**Re: NOTICE OF PUBLIC ADVERTISEMENT OF PLANNING PROPOSAL**

**NOTICE OF PUBLIC ADVERTISEMENT OF PLANNING PROPOSAL ('PROPOSAL')**  
**LOT: 39 D/P: 27736 104 MARINE PARADE COTESLOE – COTTESLOE BEACH HOTEL**

## 1520 COTTESLOE BEACH HOTEL - ALFRESCO SERVICE

Notes from discussion with Foreshore Precinct Implementation Committee (FPIC) 21st May 2018

Figure 1

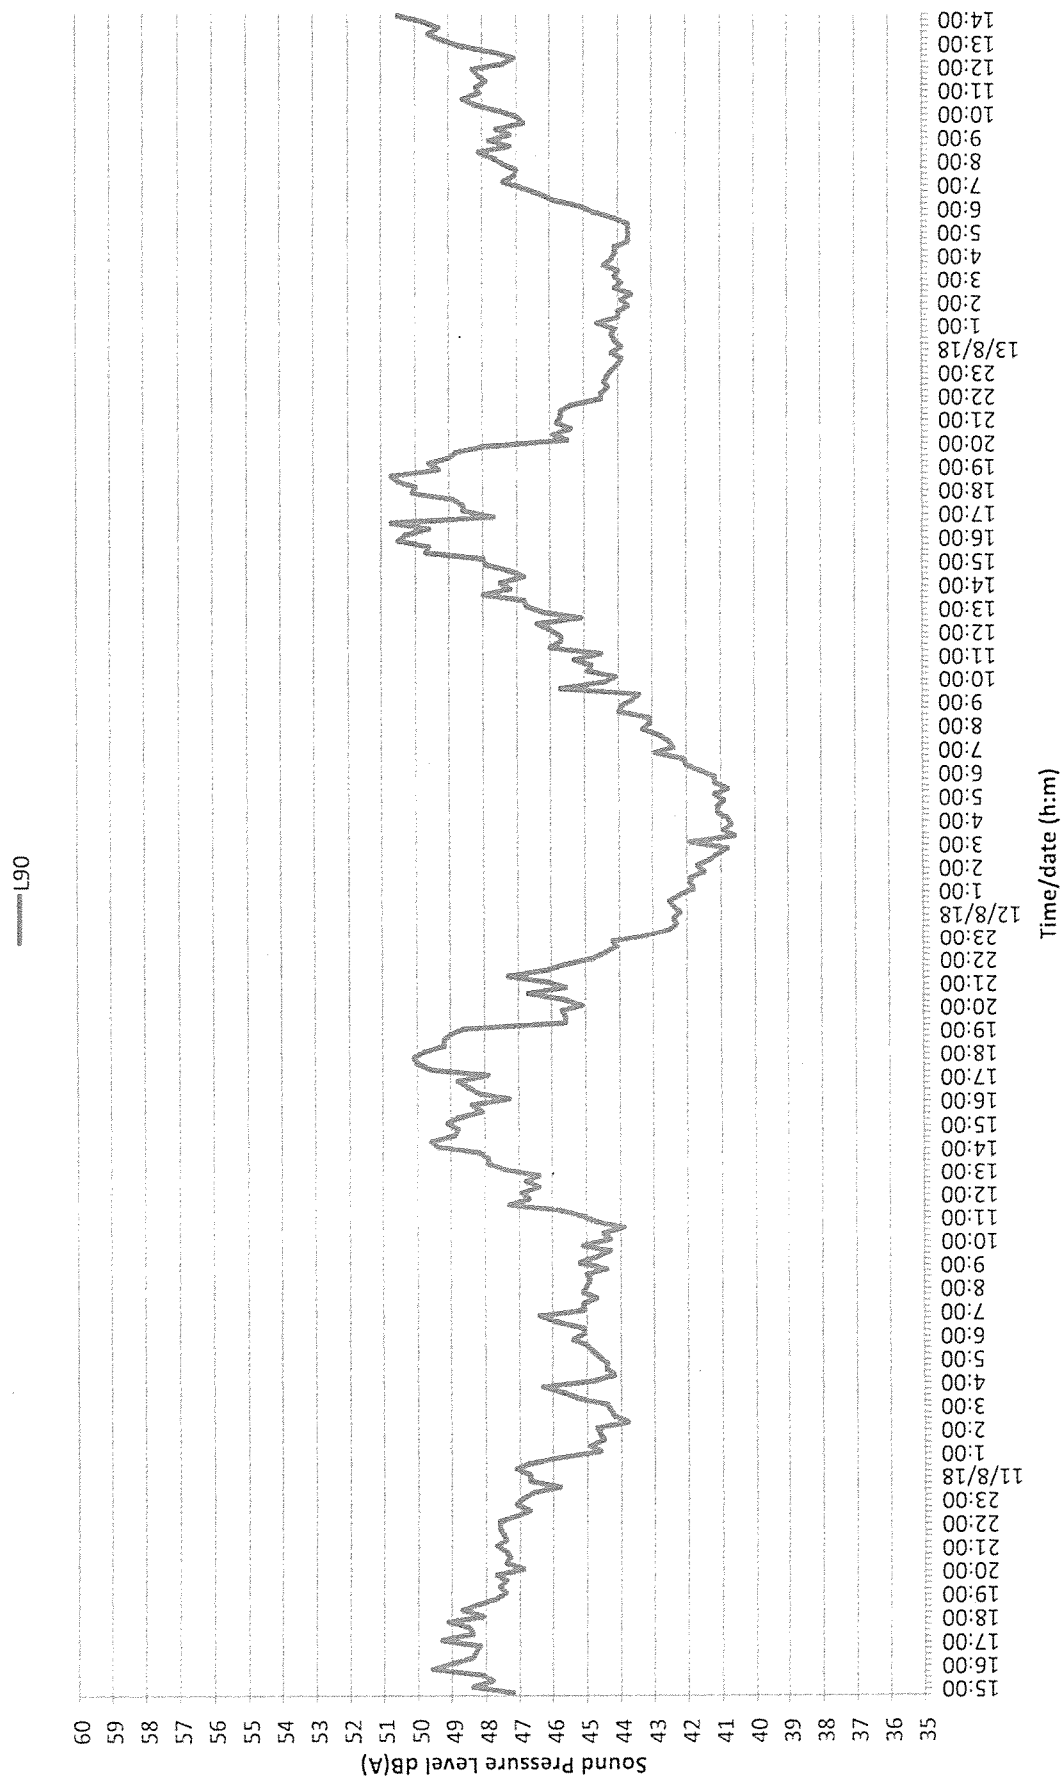
The results of the measurements are presented in *Figure 1*. These results show the  $L_{A90}$  noise levels, which is defined as the A-weighted noise level which is exceeded for 90% of the measurement period and is considered to represent the "background" noise level.

The measurement results show that the background noise levels for 4 Warnham Road are, for more than 90% of the time, between 40 to 45 dB(A) during the night rising to around 50 dB(A) during the mid-afternoon. Appendix A of *Australian Standard AS 1055.2-1997 Acoustics—Description and measurement of environmental noise Part 2: Application to specific situations*, provides noise area categories and descriptions for background noise levels and categorises these background noise levels as R3 - *Areas with medium density transportation or some commerce or industry*. This description represents the background noise level of the residences located at 4 Warnham Road, Cottesloe. The table showing all of the noise area categories in AS1055.2 -1997 is reproduced below:

DA1.2

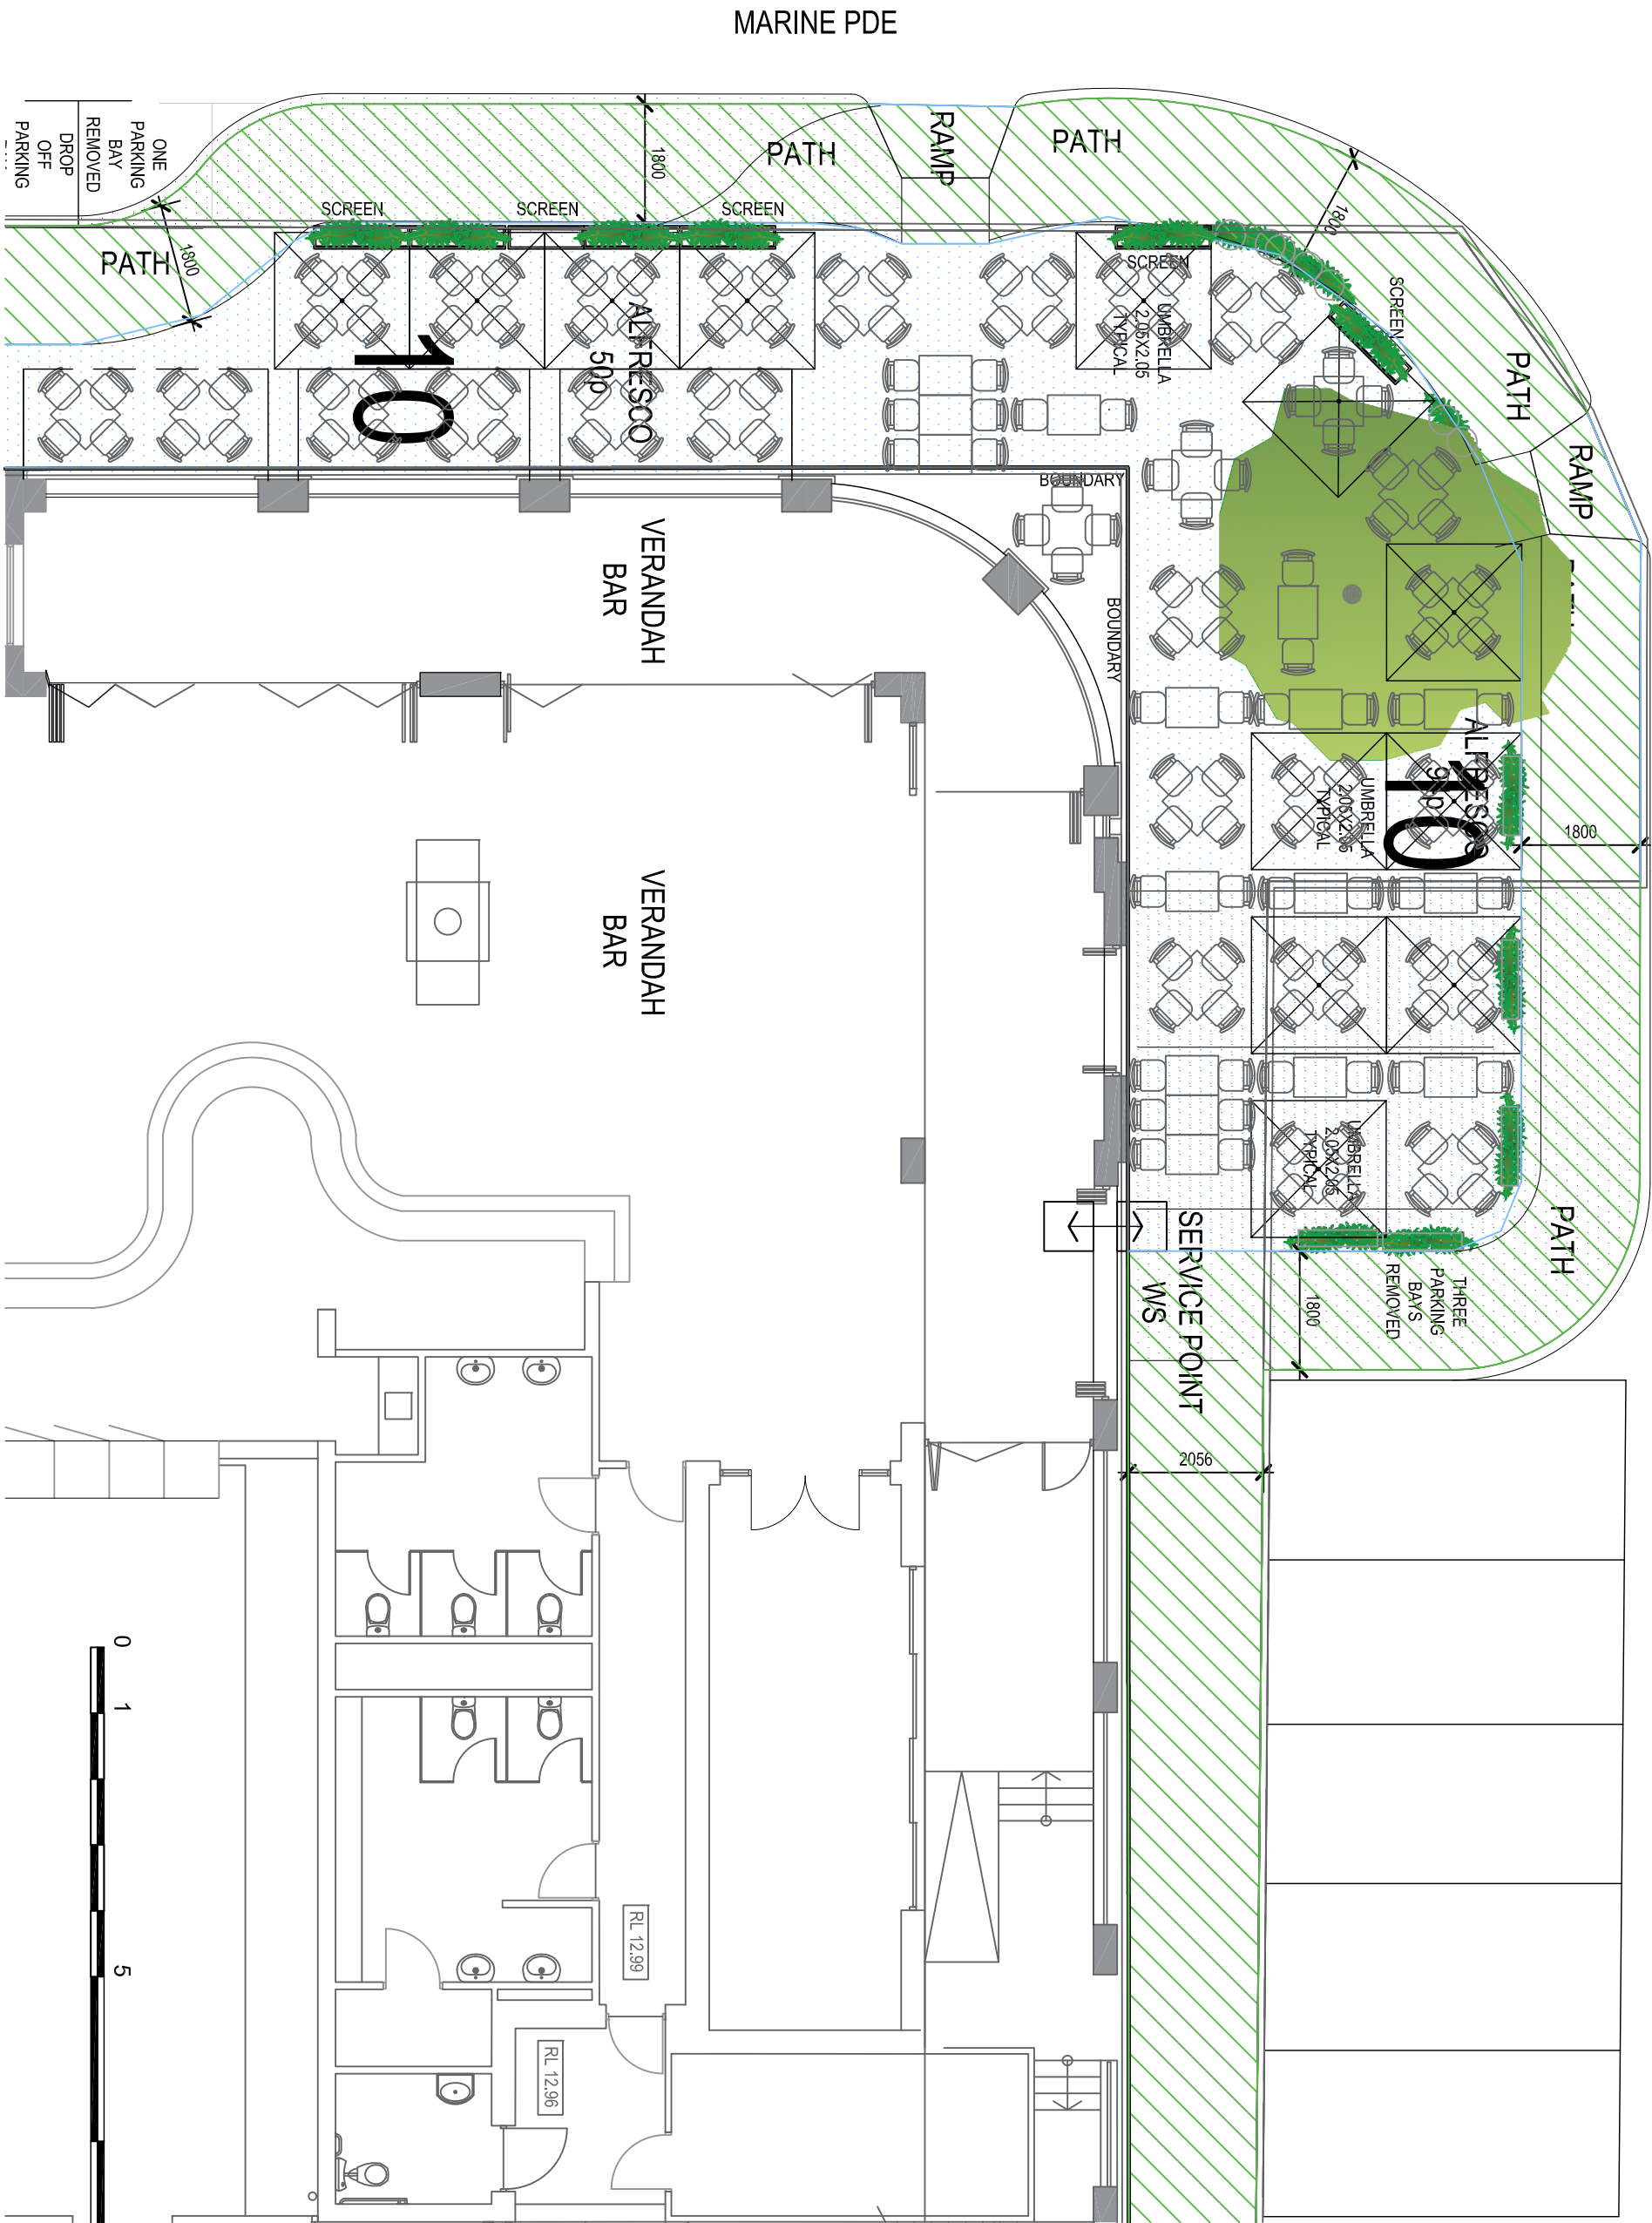
The drawing of the Proposal shows that the new alfresco area boundary on the Warnham Road side will extend out into the road further than the in situ car parking spaces do now.

The width of Warnham Road between parking areas on either side of the road is currently only six metres, making it a very narrow road for two-way traffic in an already often crowded area which is likely to become even more crowded with the creation of the alfresco area.

Further narrowing Warnham Road by building the Alfresco area into the road currently used by traffic will add greater hazard and uncertainty to what is already a narrow and busy thoroughfare.
